TECHNICAL MEMORANDUM

PEER REVIEW OF SACRAMENTO VALLEY FINITE ELEMENT GROUNDWATER MODEL (SACFEM)

U.S. Bureau of Reclamation

October 2011

Figure 16. Distribution of Deep Percolation Reduction Factors

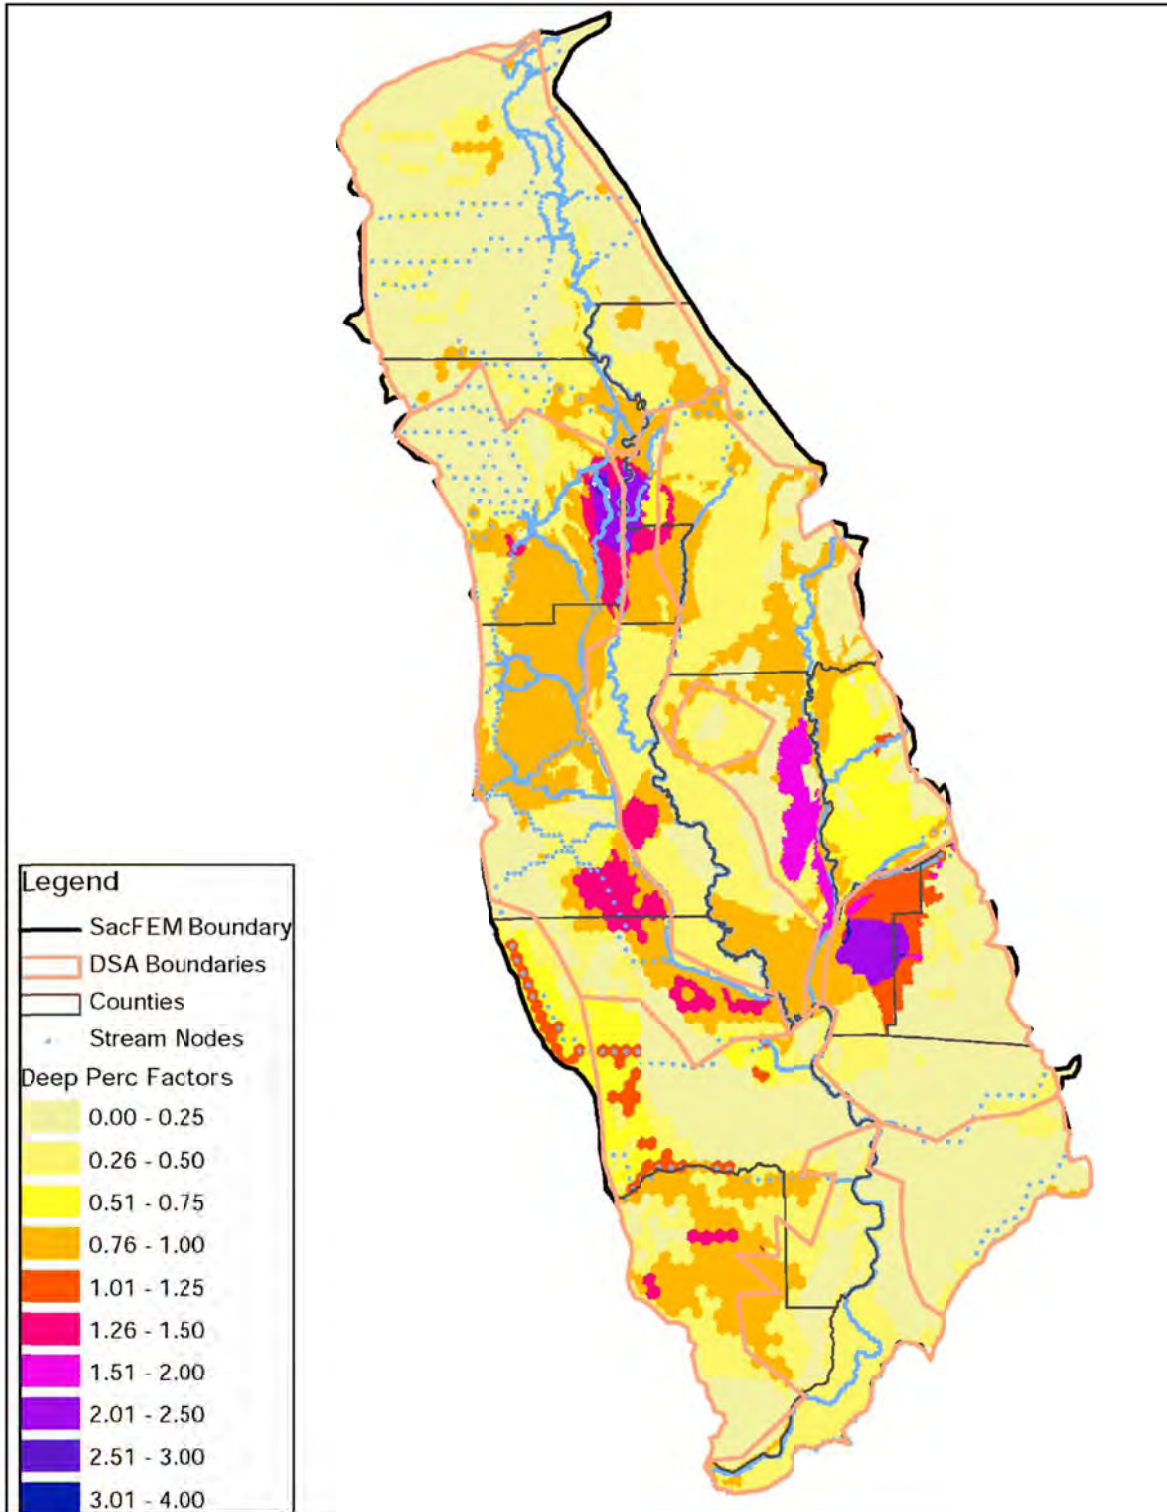
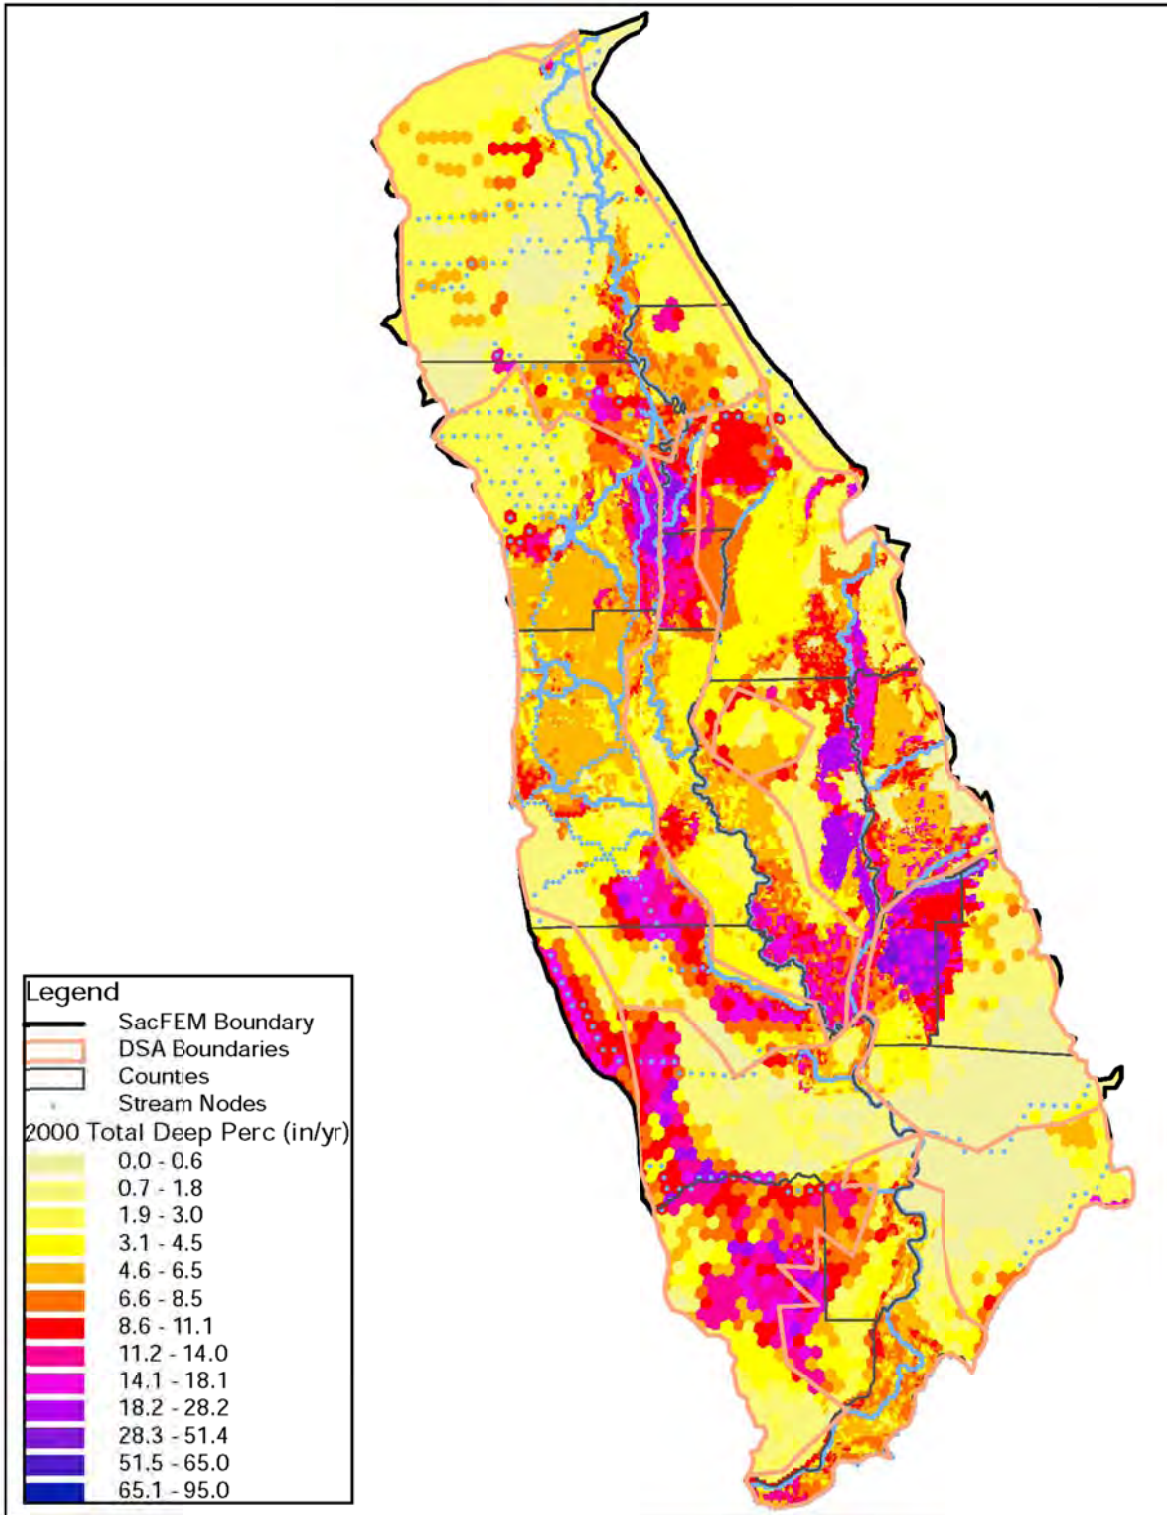
Because the IDC model deep percolation rates are significantly excessive, these rates were reduced for most parts of the model area before incorporating in SacFEM input data files. However, reduction factors are not uniformly distributed over the model area. High IDC deep percolation rates were further increased in specific areas before incorporating in SacFEM input data files. Annual deep percolation rates for the IDC model and SacFEM for the entire model area for 1970 to 2003 are shown in Figure 15. Average annual deep percolation volumes, rates, and reduction ratios factors by Depletion Study Areas (DSAs) are presented in Table 4. The distribution of deep percolation reduction factors is presented in Figure 16. The distribution of SacFEM total deep percolation rates is presented in Figure 17.

Reduction of the IDC model deep percolation rates in much of the model areas is reasonable; however, increasing deep percolation rates in specific areas results in significantly excessive deep percolation rates. More importantly, some of the excessive deep percolation areas correspond to project areas.

SacFEM final deep percolation rates are not supported by the fundamental IDC model methodology and parameters, resulting in a disconnect between the IDC model and SacFEM. It is recommended to incorporate a feedback loop between the IDC model and SacFEM deep percolation estimation with an appropriate convergence level between the two models (Figure 18). It is further recommended to make appropriate adjustments in the IDC model parameters on a monthly basis to develop revised deep percolation estimates for SacFEM. Because SacFEM deep percolation factors are not consistent with distribution of other data sets, it should be ensured that agricultural demand, groundwater pumping, and deep percolation estimates are supported by historical land use, crop mix, and agricultural practices.

Figure 21. SacFEM Total Annual Stream Gains/Losses

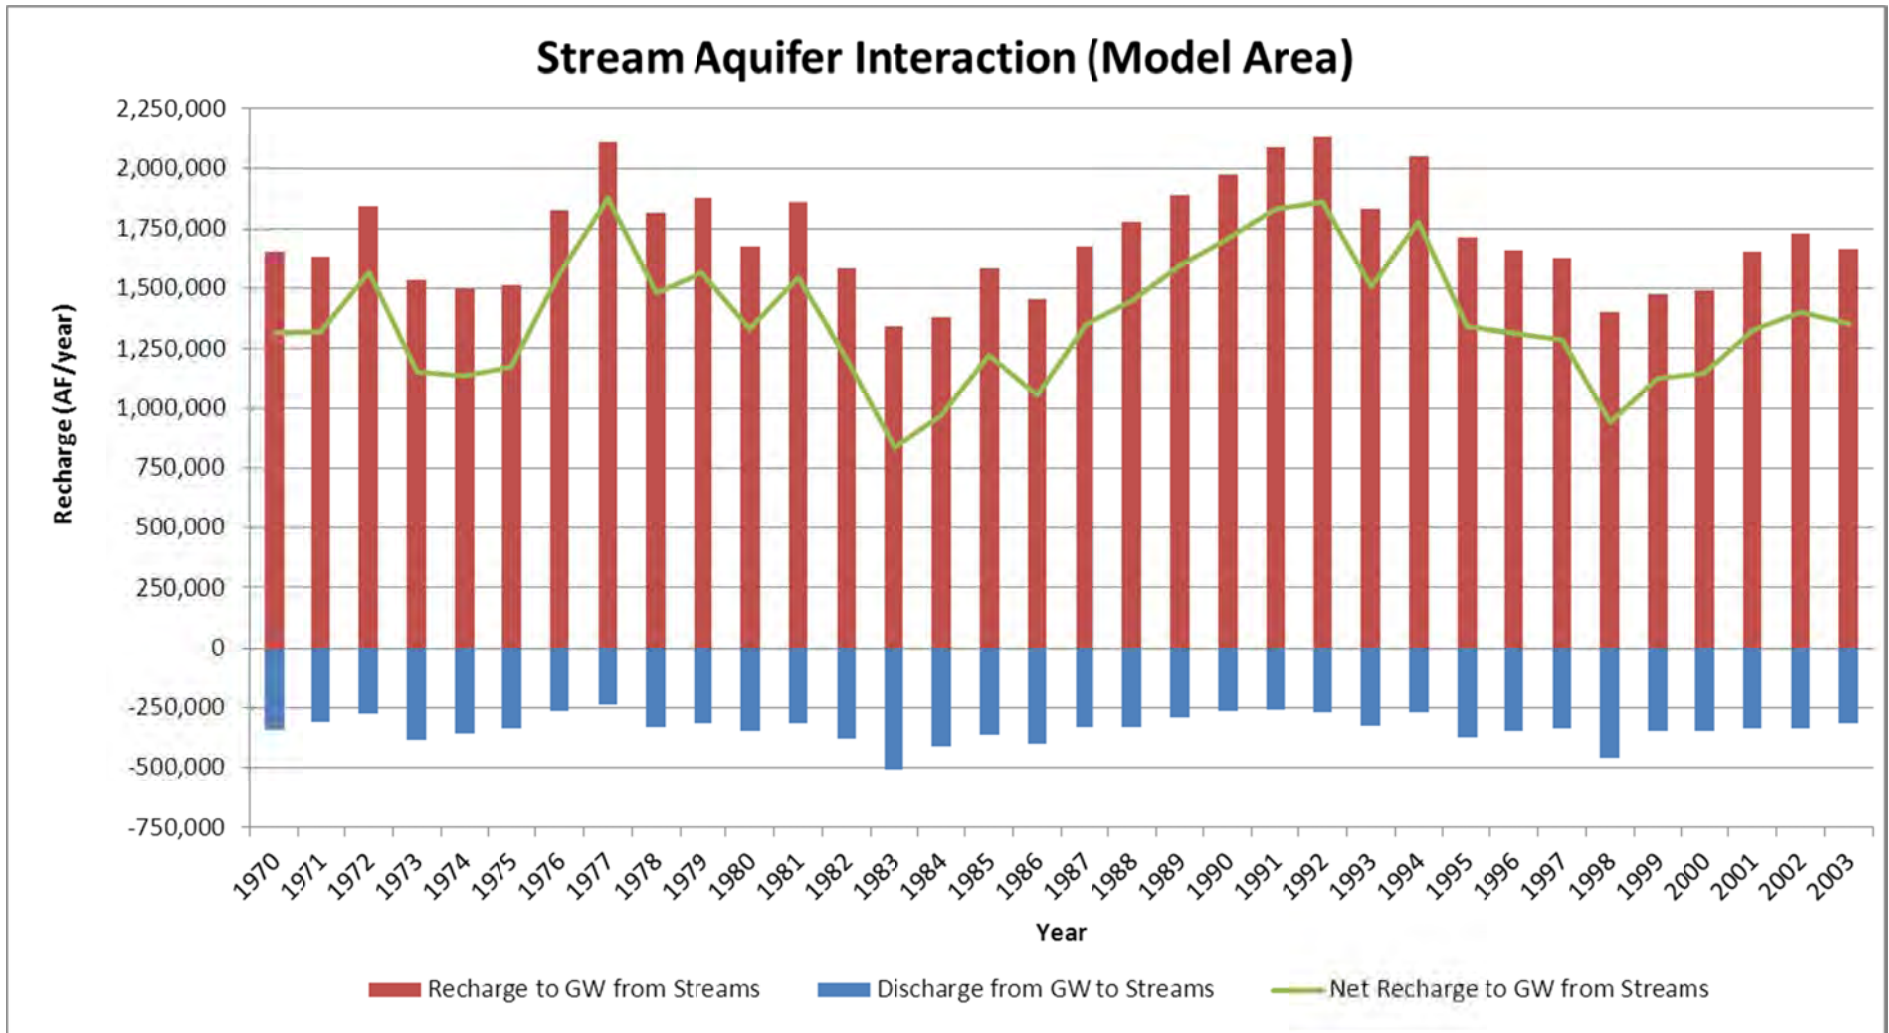
SacFEM stream gains and losses were compared to hydrological conditions of normal, dry and wet years. SacFEM total annual stream gains and losses for the entire model area are presented in Figure 21. SacFEM estimates higher stream losses in dry years such as 1976 and 1977, and lower stream losses in wet years such as 1983.

In the absence of stream stage data, adjustments of streambed resistances during the calibration process are used by some modeling efforts to fine tune the stream-aquifer interaction. However, for SacFEM the surface water stage fluctuations and groundwater level fluctuations are large enough to make a difference in stream gains and losses calculations and show that the assumption of constant stream stage is not valid. It is recommended that SacFEM use temporally varied stream stages on a monthly time step based on monthly streamflows. It is also recommended that the variable stream stages of regulated streams be revised for each SacFEM application scenario. Adjustment of streambed resistances may be used during SacFEM calibration after the stream stage data are incorporated in SacFEM input data files.

Figure 23. Net Stream Gain/Loss for Feather River at Oroville and Yuba City

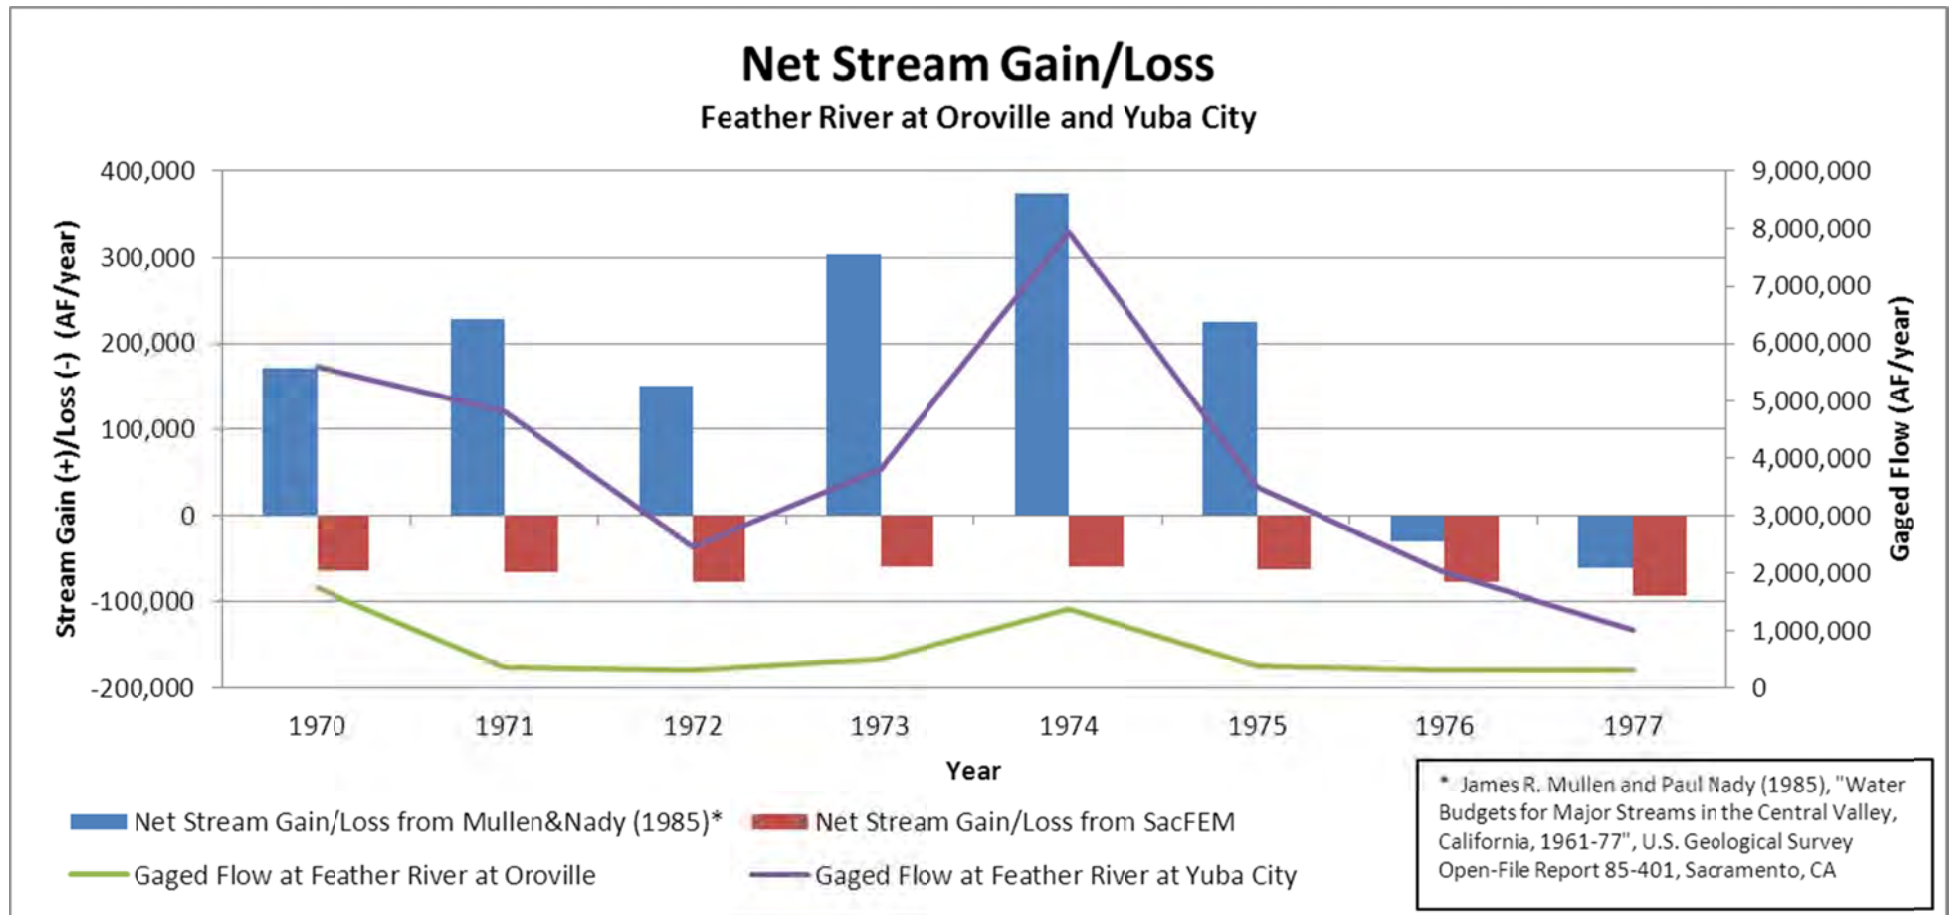
Feather River – A comparison of stream gains and loss estimates by SacFEM and the USGS study for Feather River at Oroville and Yuba City is presented in Figure 23. The USGS study shows this reach as a gaining and losing reach of Feather River; however, SacFEM consistently shows losses. SacFEM over estimates stream losses in the dry years of 1976 and 1977.

Figure 24. Net Stream Gain/Loss for Yuba River below Englebright Dam and Near Marysville

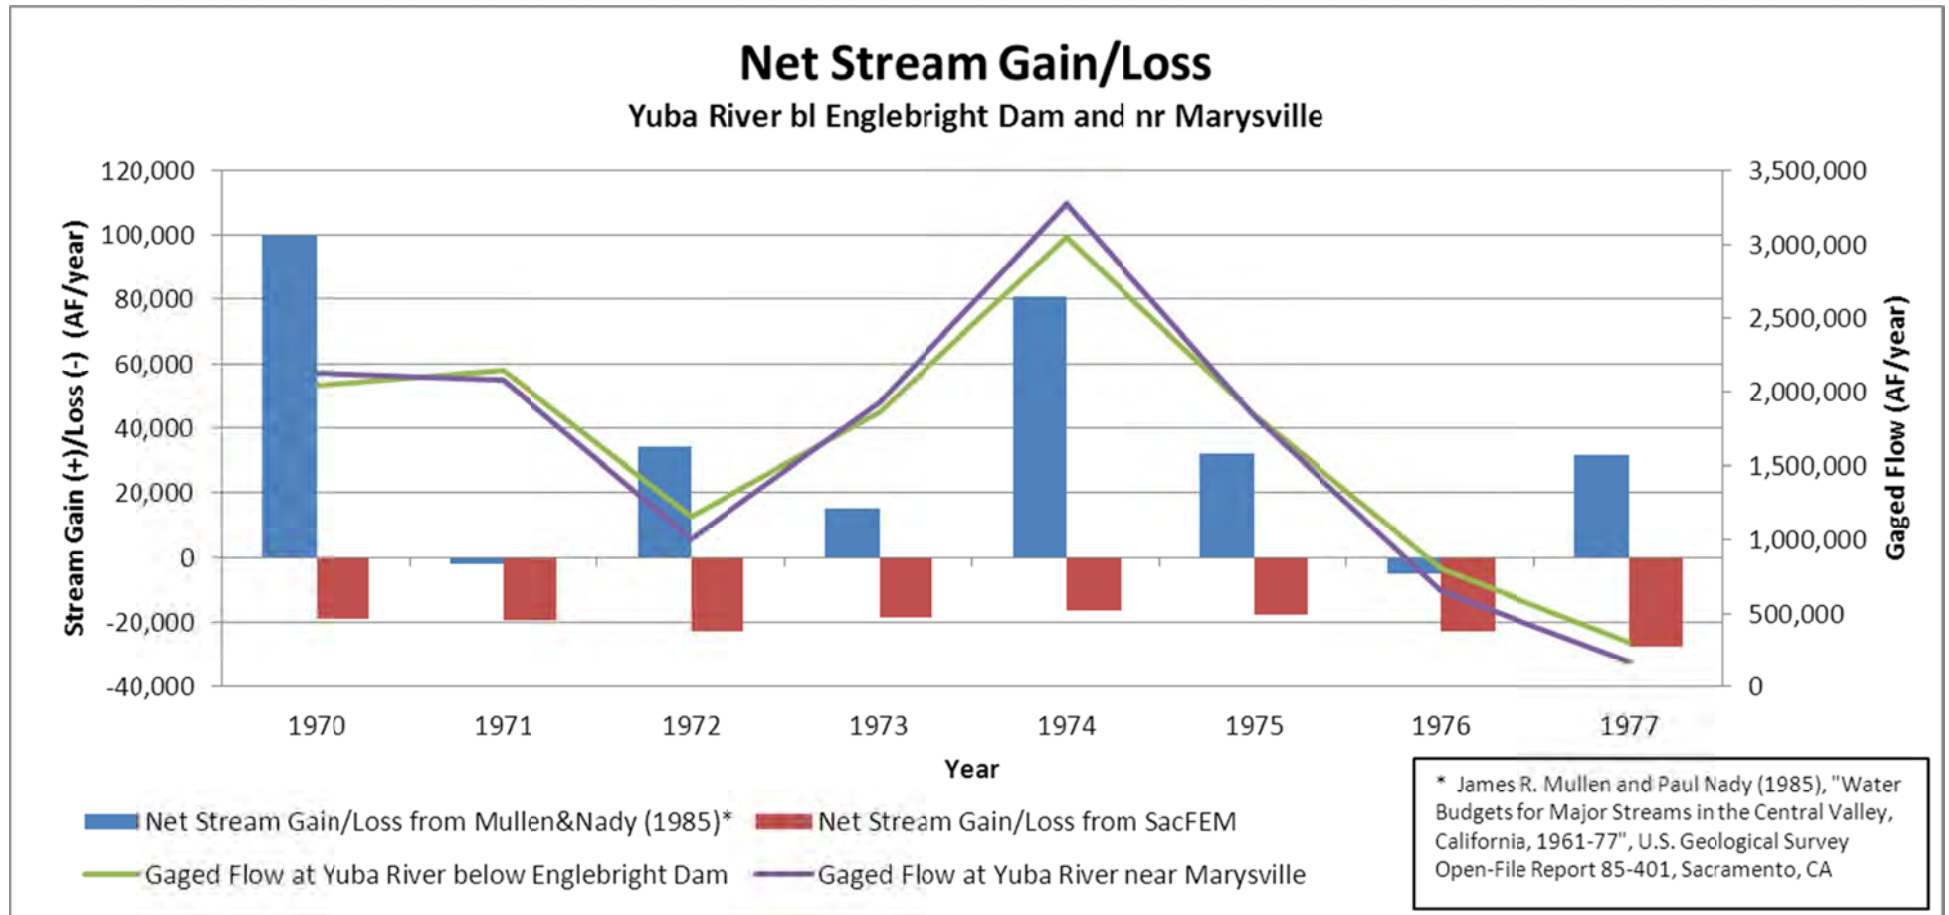
Yuba River – Stream gains and losses for Yuba River below Englebright Dam near Marysville are shown in Figure 24. The USGS study shows this reach as a gaining and losing reach; however, SacFEM shows losses consistently. SacFEM shows significant stream losses in 1977, while there were near zero flows in 1977.
